**RE: Mail Control Number: 578146**  
**Radioactive Materials License Application for:**  
Spring Hill Cardiology, PLLC  
428 Division Street, Suite 1A  
Charleston, WV 25309-1469

**9.1 Facility Diagram**

Overview Diagram:

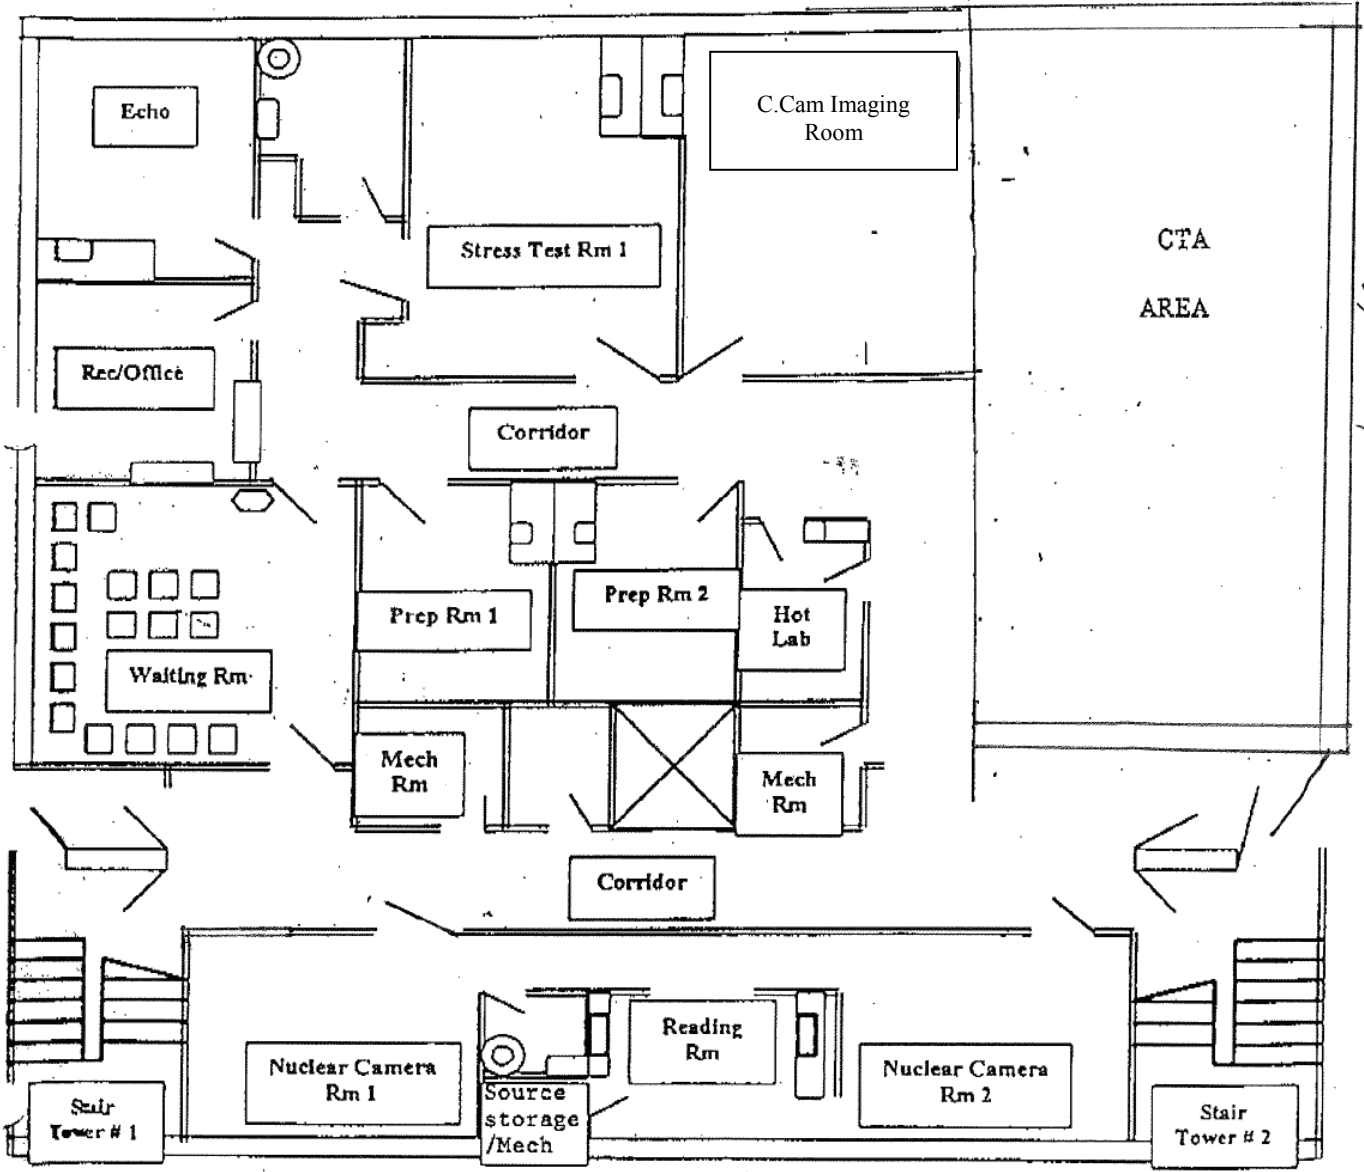
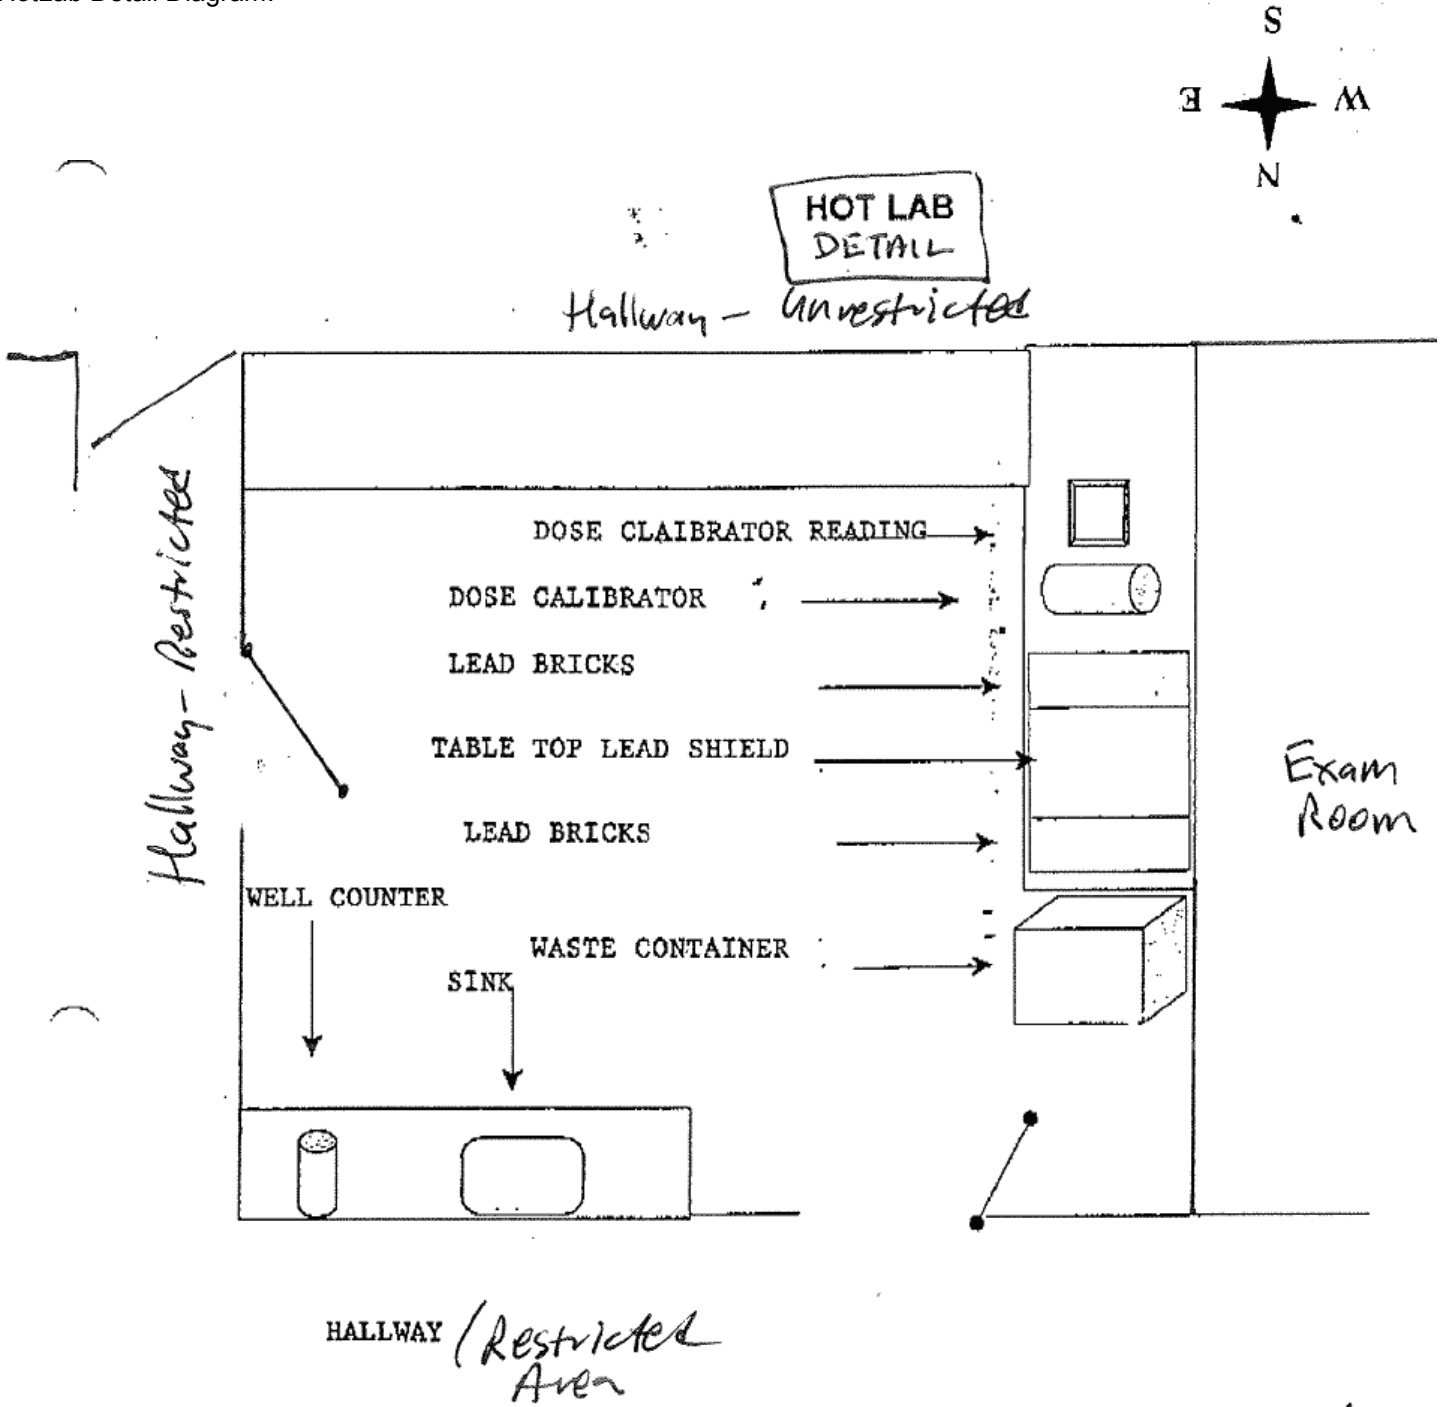
We wish to make a change to the facility layout of our radioactive materials application. We would like to install a Siemens C.Cam dedicated nuclear cardiology gamma camera in what is currently known as Stress Room 2 which will subsequently be known as the C.Cam Imaging Room as shown on the attached diagram. For your review, please find the attached revised Item 9.1. Please replace the previously submitted Item 9.1 with this revised version. There are no other changes that affect our application.
